United States Nuclear Regulatory Commission Official Hearing Exhibit																									
In the Matter of:	POWERTECH USA, INC. (Dewey-Burdock In Situ Uranium Recovery Facility)

# Safety Evaluation Report for the Lost Creek Project, Sweetwater County, Wyoming, Materials License No. SUA- 1598

Docket No. 40-9068  
Lost Creek ISR, LLC

**U.S. Nuclear Regulatory Commission**

**Figure 2.6-5: 2009 Vegetation and Soil Sampling Locations**

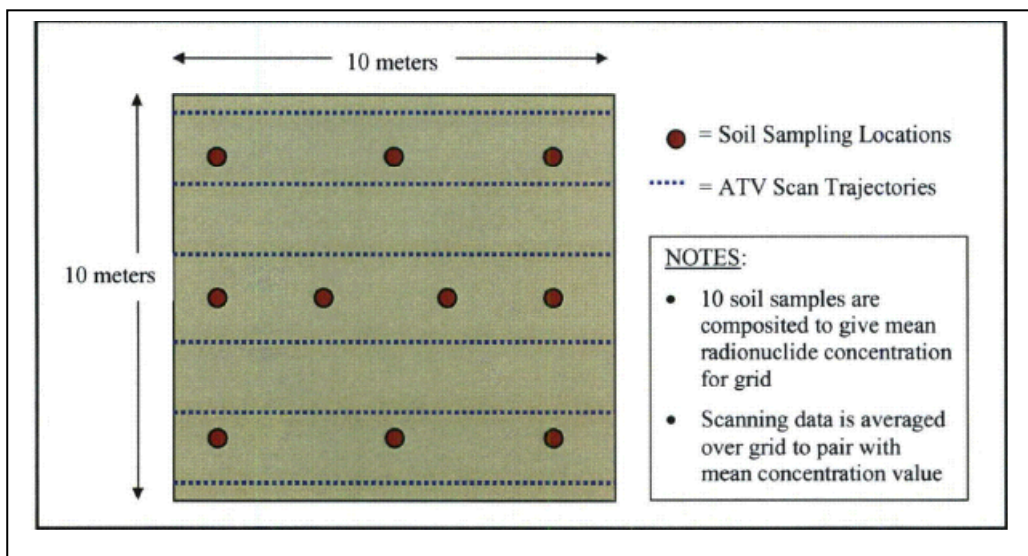
According to the applicant (LCI, 2010a), sampling locations D and E within the plant boundary in SER Figure 2.6-5 were predicted by MILDOS-AREA modeling to have the most ground concentrations of radon progeny during operations. Locations F, G, H, and I (see SER Figure 2.6-5) were areas that the direct gamma scan survey (described in SER Section 2.6.3.4) indicated elevated gamma activity. The applicant stated that location J (see SER Figure 2.6-5) measured background exposure readings in the baseline direct gamma scan survey and was upwind during operations where MILDOS-AREA modeling predicts radon deposition to be low or non-existent (LCI, 2010a). The NRC staff finds that the applicant collected and analyzed the revised baseline vegetation sampling consistent with Regulatory Guide 4.14 because the applicant sampled forage vegetation at least three times during the grazing season in grazing areas in three different sectors having the highest predicted airborne radionuclide concentration due to milling operations, as recommended in the regulatory guide.
